Shore Physical Education Centre
Section 4.55(1A) Application for Modification (SSD 7507)
Blue Street, William Street and Hunter Crescent, North Sydney

Section 4.55(1A) Application for Modification

Revised Statement of Environmental Effects to
NSW Department of Planning, Industry and
Environment and Public Spaces

10 December 2019 | 1382

Figure 4 – PROPOSED Bishopsgate car park roof terrace: Landscape Design (Source: Oculus, Revised Masterplan Concept Plan - Section 4.55 Submission, page 20)

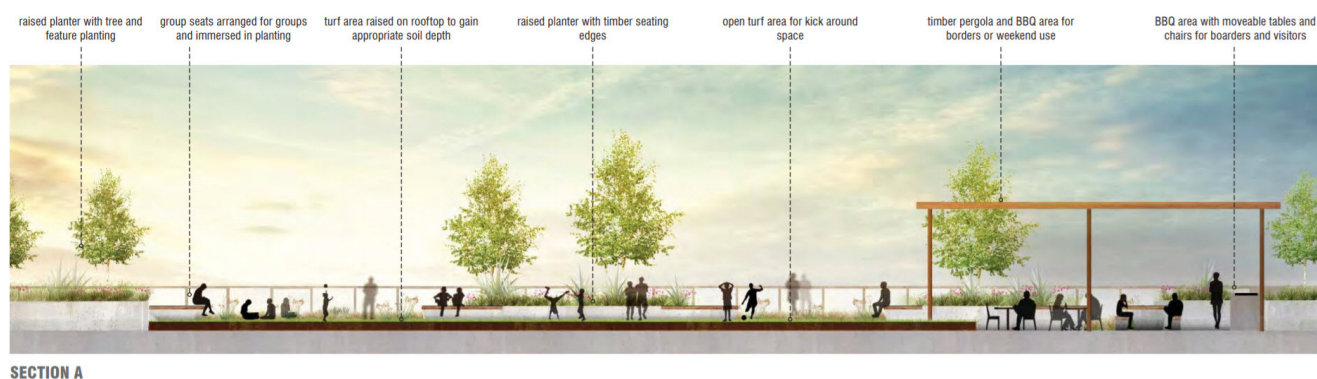
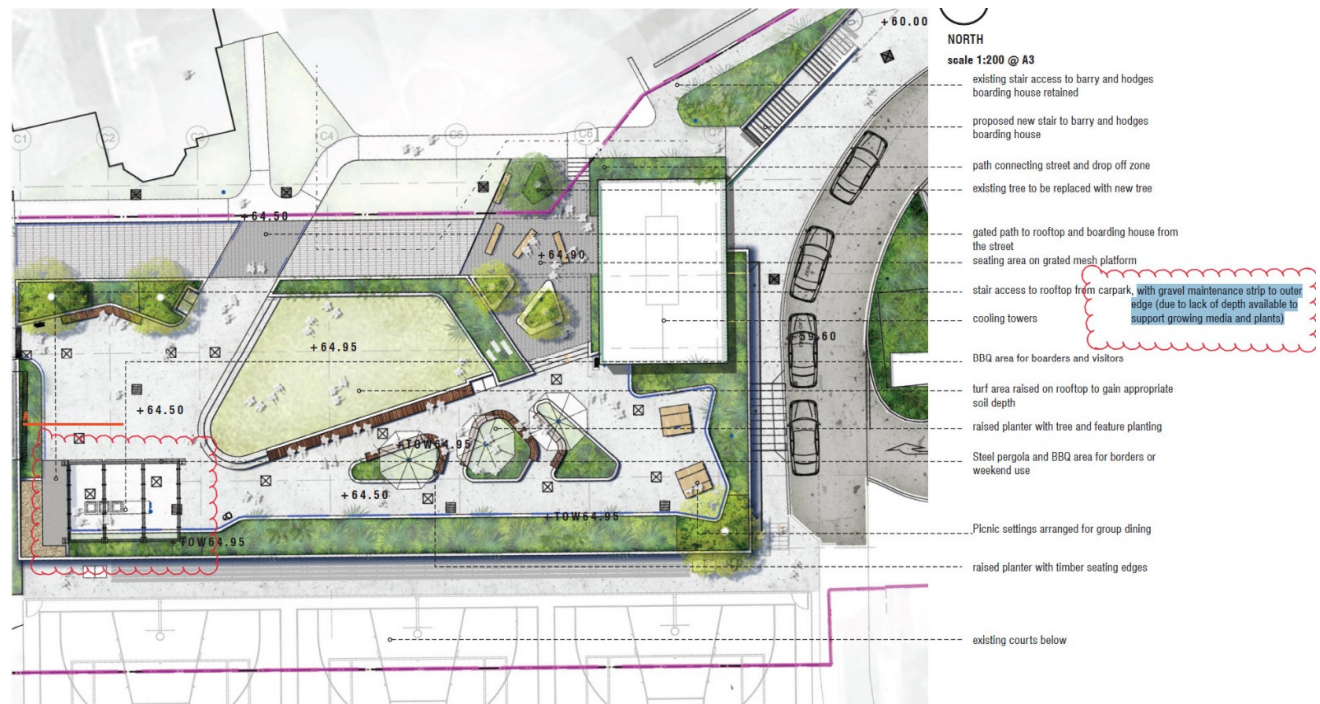
1. **Barbecue area with shelter:** Minor changes are proposed to the landscape design of the Bishopsgate car park roof terrace, including a barbecue area with steel barbecue shelter in the western corner of the Bishopsgate car park roof terrace. The barbecue area is proposed as an outdoor recreation space for Shore boarders. The Landscape Design Report included in the Environmental Impact Statement (**EIS**) shows a barbecue area with a timber pergola on the roof terrace (see **Figure 3**). This design was inadvertently not shown on the stamped architectural and landscape plans (see **Figures 5 and 8**).

- *provide details of the treatment of the area (shown in brown on the revised landscape plans) to the south-west and north-west of the new stair access to the rooftop terrace and previously to be planted.*

- **Landscaping:** Landscaping is proposed along most of the southern, eastern and western edges of the roof terrace (see **Figure 4**). The small section of terrace edge adjoining the stair which is to be finished with gravel is very minimal when compared with the predominantly

Response: Oculus has prepared an Amended Landscape Design Report (see **Appendix B**) which shows that the relevant area is to be finished with gravel maintenance strip to outer edge (due to lack of depth available to support plants). This area is setback more than 40m from Union Street, is not visible from the public domain and the absence of plants will not be apparent to passers by (on or near the site).

Figure 6 – PROPOSED General Arrangement Car Park Roof Top (Source: COX, Revised A-DA-2192, Revision 05)

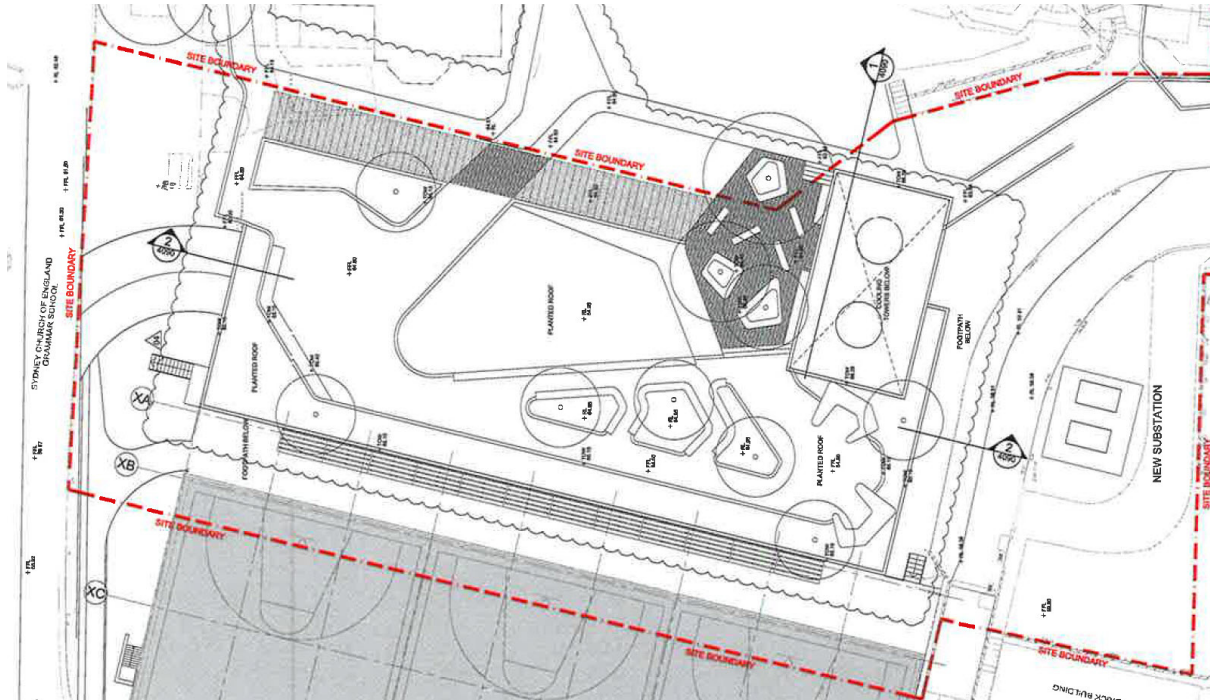
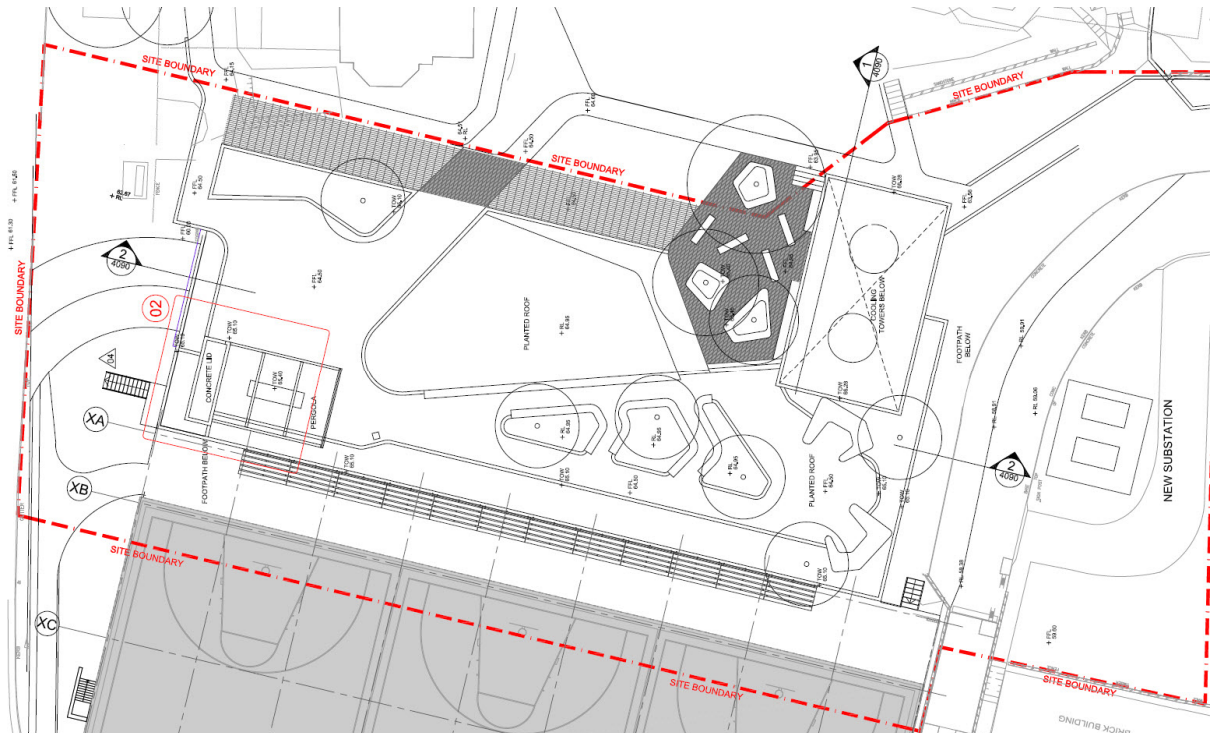
2. **Improved pedestrian connections:** The approved Bishopsgate car park plans do not provide stair access between new student drop-off/pick-up facilities on the First Floor and car park roof terrace. This reduces pedestrian convenience and safety and does not maximise the separation of students and cars. To provide for better pedestrian connections between the drop-off/pick-up facility, the roof terrace and wider campus and to improve student safety, the Section 4.55 proposal extends the approved stairs to the roof terrace. A new stair overrun rises above the roof terrace, sitting well below the 8.5m height standard. **Figures 10 and 11** compare the approved and proposed Bishopsgate car park section.

Figure 7 – PROPOSED Stair details – plan and elevation (Source: COX, Revised A-DA-2190, Revision 05 and A-DA-3090, Revision 04)

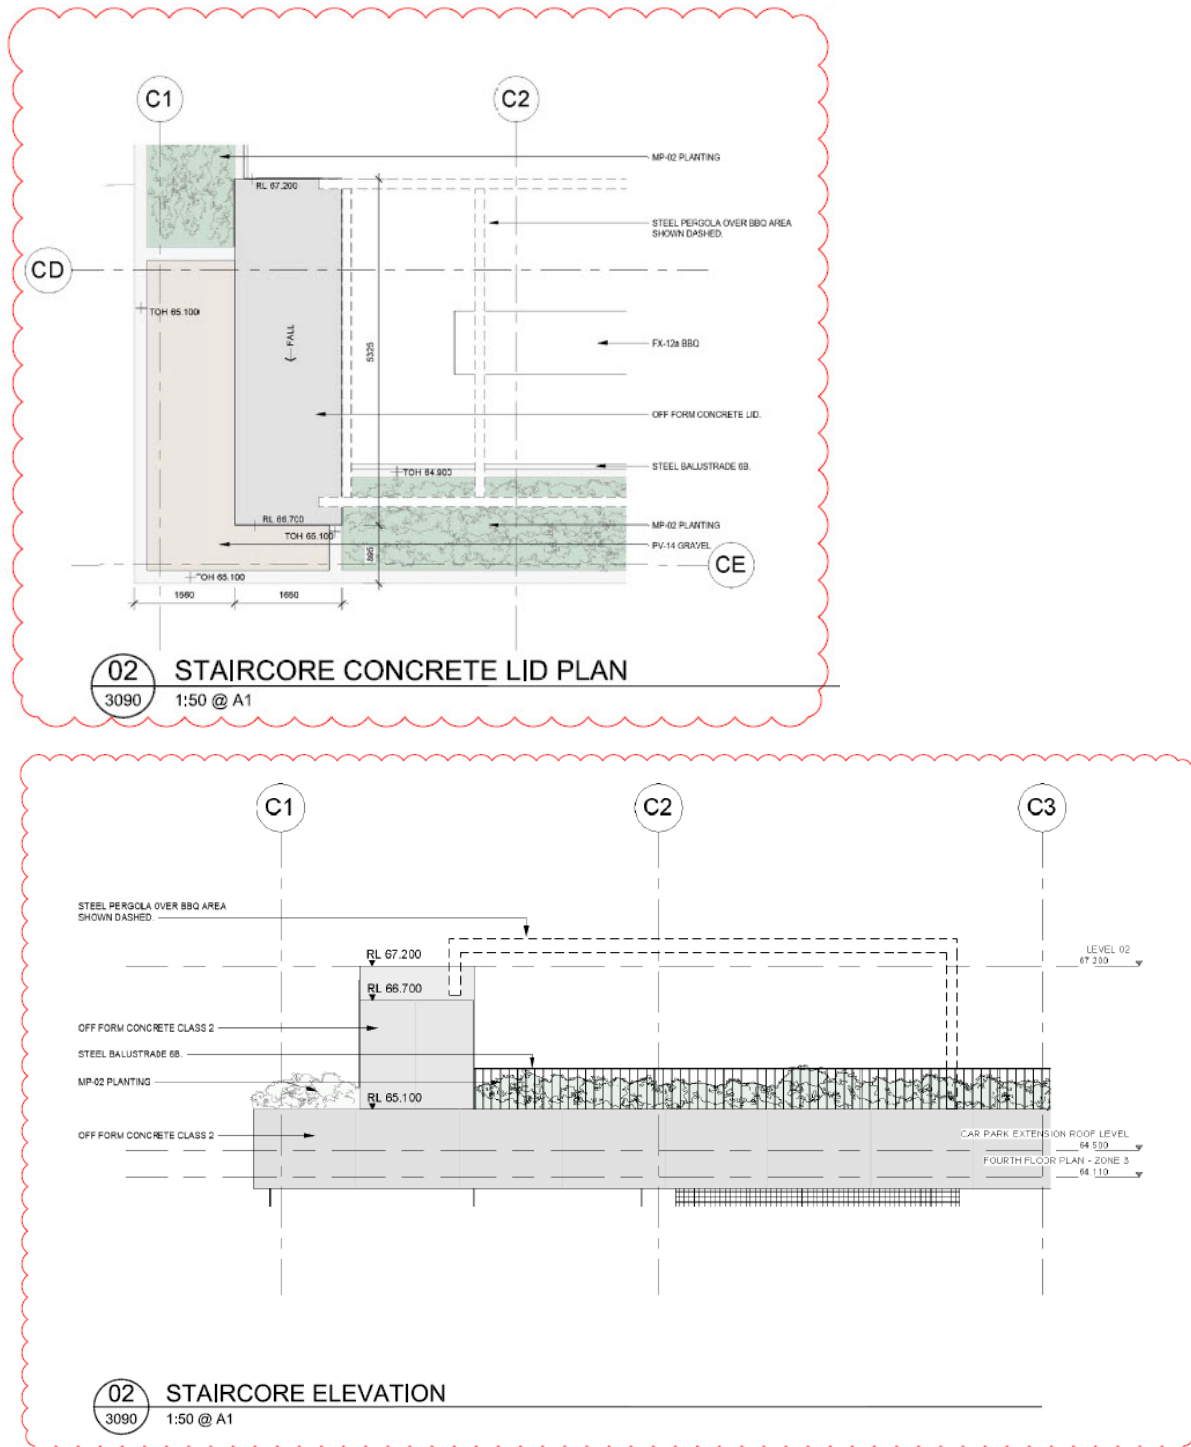
- *provide detailed elevations and façade treatment proposed for the new stair access to the rooftop terrace.*

Response: Cox has prepared Amended Architectural Plans (see **Appendix A**) which include a detailed elevation for the new roof top terrace stair access. Drawing A-DA-4090 – Section 03 shows that the stair elevations comprise Off Form Concrete. Again, this area is not visible from the public domain.
